PUBLIC COMMENT MT. SAN ANTONIO COLLEGE WEST PARCEL SOLAR PROJECT SCOPING SESSION

WRITTEN COMMENTS TO SCOPING MEETING FOR WEST PARCEL SOLAR PROJECT, JUNE 7, 2017

UNITED WALNUT TAXPAYERS PRELIMINARY REVIEW OF NEGATIVE GEOTECHNICAL AND GEOLOGICAL ASPECTS OF CONSTRUCTING EARTHFILL PAD FOR A SOLAR FARM ON THE WEST PARCEL - DRAFT

Attachment Google Earth Image of Existing Landslide at West Parcel Site

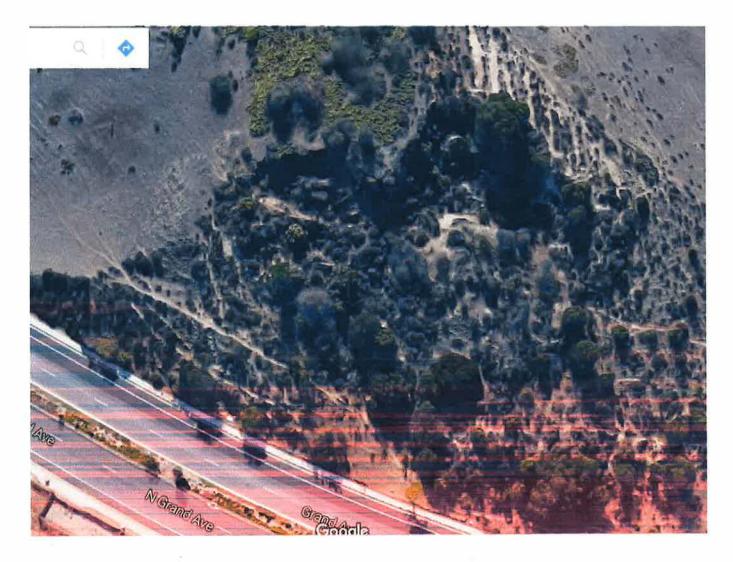
vii. The Converse report did not recognize a significant landslide in the central hill of the project site present for more than thirty years (see Google Earth attachment), which is vulnerable to further sliding.

iv. Aerial imagery from Google Earth clearly indicates landslide(s) exists on the eastern side of the central knob descending down to Grand Avenue (see attachment). The landslide area on the central hill is present in aerial imagery dating from after 1980 until the present.

v. The above referenced landslide is further validated through field visits to the site by our Engineering Geologist and former City officials with first-hand knowledge of at least two landslides that occurred at the subject site after Grand Avenue was expanded to four lanes.

vi. At least one of the above landslides at the central hill of the site closed the road (Grand Ave.) and covered all the lanes. In addition, siltstone and shale bedrock with eastward dipping bedding subject to landsliding was observed in this area.
